NO. SI 20E-013

Type: DV 20 E, all airplanes

BRP-Rotax GmbH & Co KG Service Bulletin SB-912 i-014

Exchange of propeller shaft on ROTAX® Engine type 912 / 914 (Series) and 912 i (Series)

Fig. 1

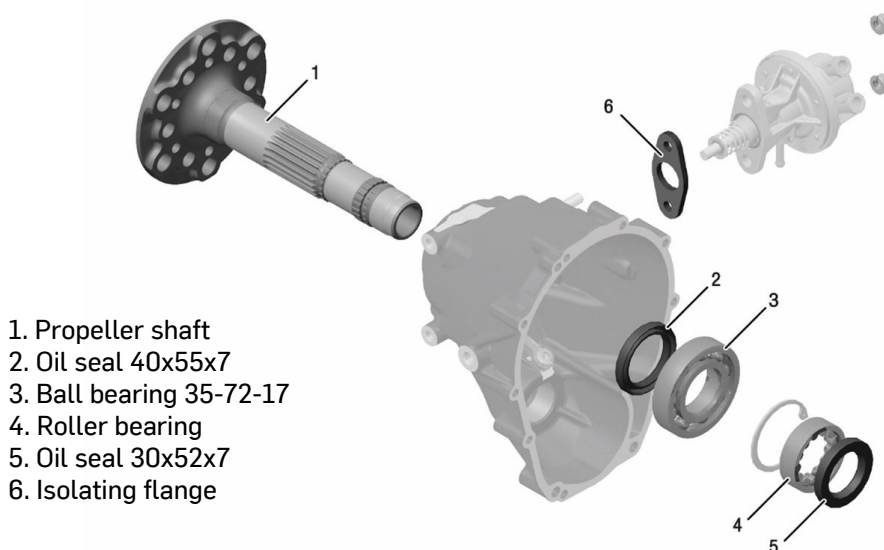
See Fig. 1.

Parts requirement in case of replacement:

Part no.	Qty/engine	Description	Application
937047	1	Propeller shaft	Version 2
832587	1	Ball bearing 35-72-17	Gearbox side
950470	1	Oil seal 40x55x7	Gearbox side
232246	1	Roller bearing	Crankcase side
950200	1	Oil seal 30x52x7	Crankcase side
950228	1	Isolating flange	Fuel pump (912 Series)
